Friends of Native Wildlife Inc.  
[info@bayfonw.org.au](mailto:info@bayfonw.org.au)

28 May 2024

Re: Draft Wangara Road Master Plan

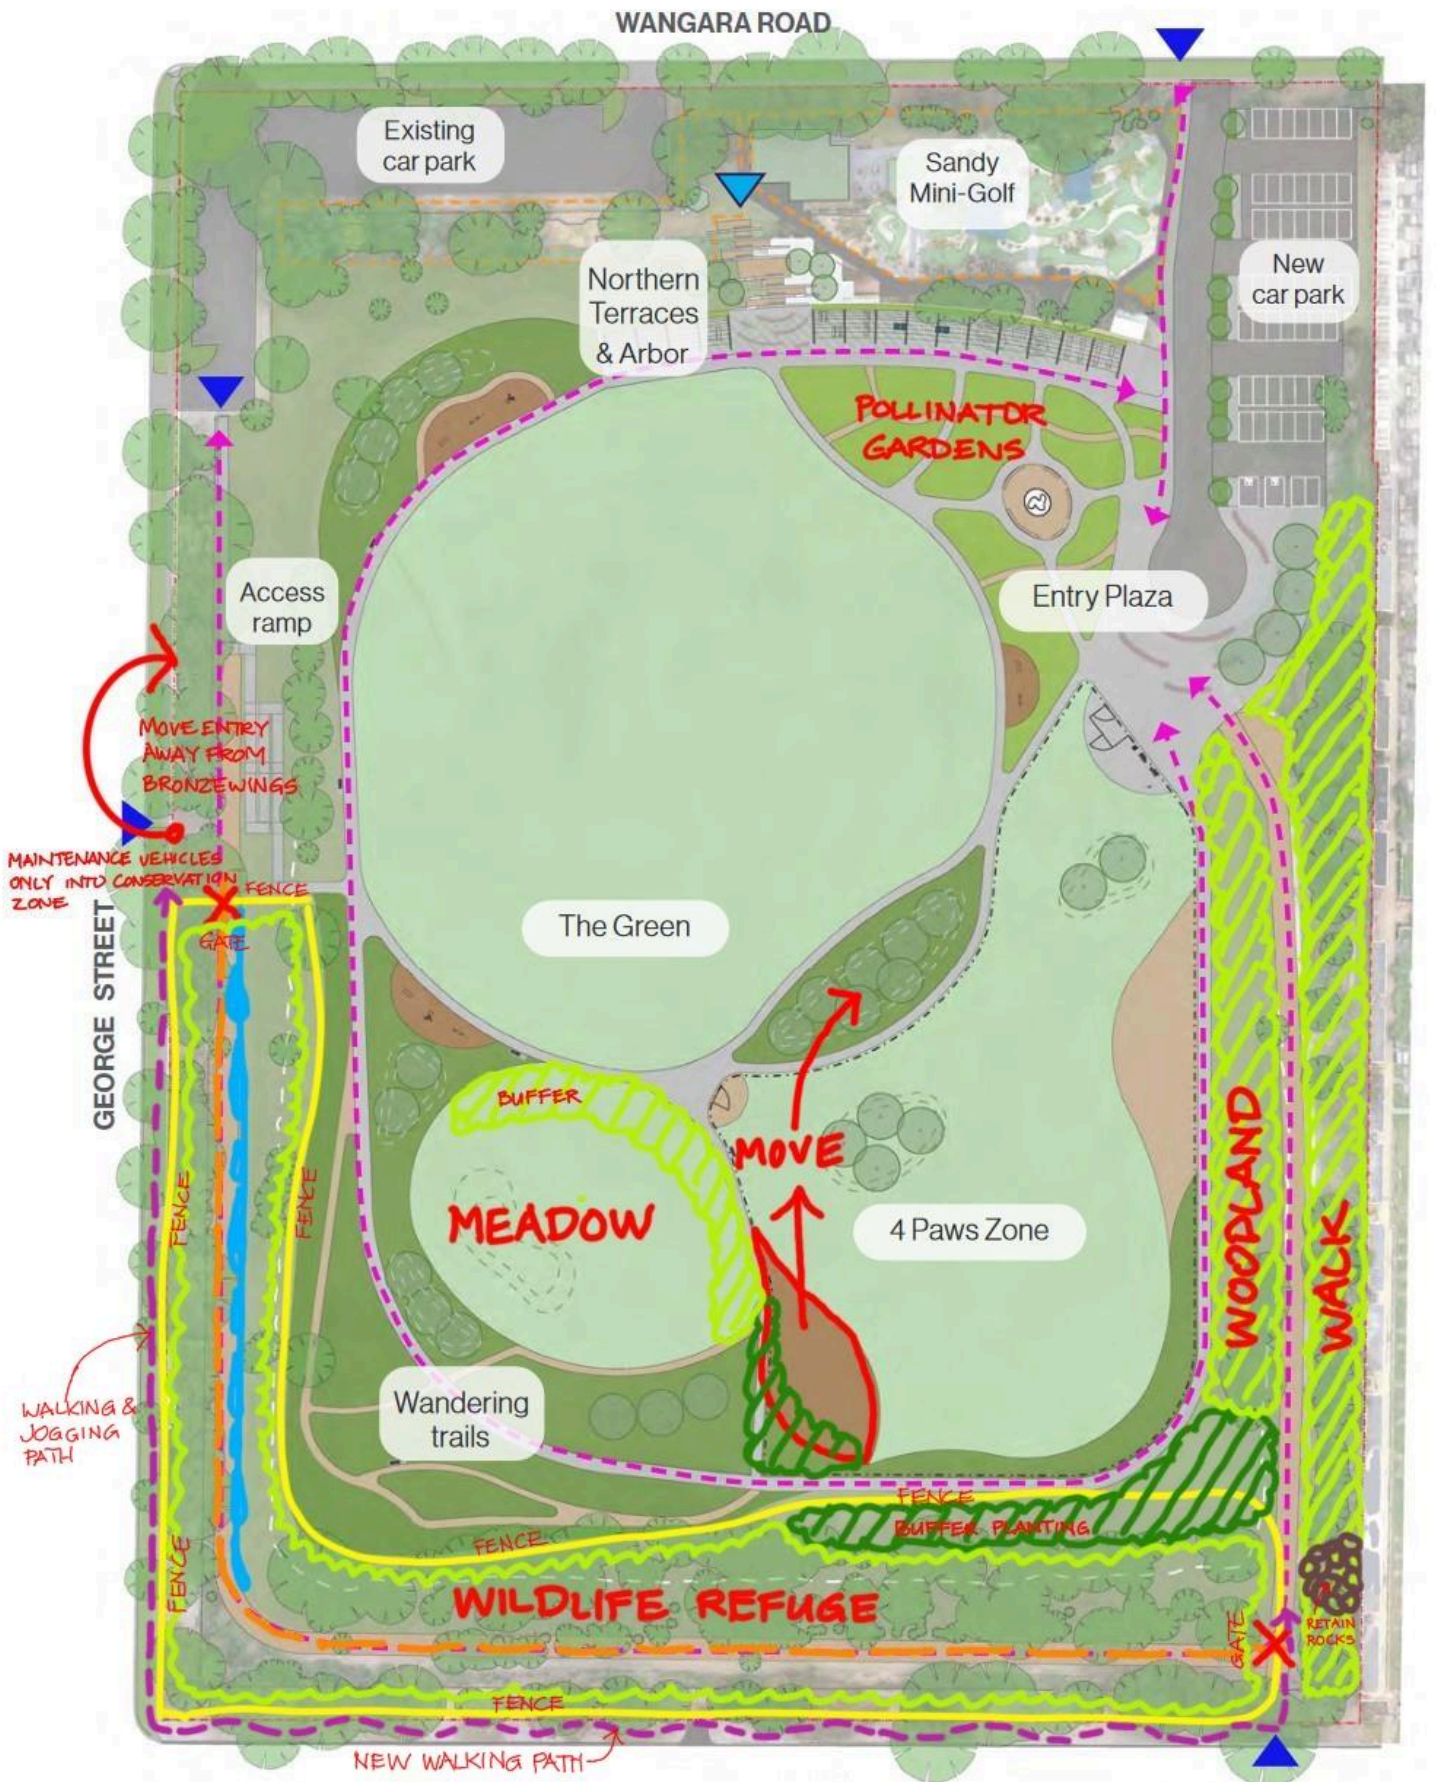
At Wangara Rd Council has the opportunity and responsibility to help ensure the continued existence of the Bronzewing in Bayside. The key Bronzewing area is only a small part of the Wangara Road site. We suggest that a more effective refuge for these birds (and other fauna) would be ensured by providing a fenced habitat area (**refer attached plan**). The fence would be high enough to discourage people and dogs from traversing the area. An alternative route for the "perimeter trail" could be provided in the adjoining road reserves as indicated on the attached plan.

Potentially, the proposed swale on the site could be designed to hold some water as a small wetland (**refer attached plan**). It could also be a series of wetlands providing bio-filtration of pollutants. A self-filling water bowl could be installed and/or access could be provided to volunteers to maintain water bowls in the refuge. FoNW has a network of volunteers who maintain water bowls. Provision of water inside a Bronzewing refuge would also benefit other fauna. For example, a small wetland may assist dispersal of frogs from nearby Pobblebonk Park.

Our recent wildlife monitoring on the site found a rich and diverse microbat population on the site. We observed that after mowing of the area, the presence of microbats decreased markedly. The microbats, Bronzewings and other seed eating birds that use the site, such as Eastern Rosellas, would benefit from an unmown or infrequently mown native grassland area close to the refuge. It would be an asset for such fauna, would discourage Noisy Miners, increase biodiversity and would provide an educational opportunity for users of the site. A potential area for this is indicated on the **attached plan**.

We suggest that a generous buffer of plantings be provided between the dog off-leash area and the refuge area to reduce visual, light and noise disturbance close to the refuge (**refer attached**

**plan**). There could also be a small, lower height, buffer to demarcate the more quiet and relaxed Meadow area.
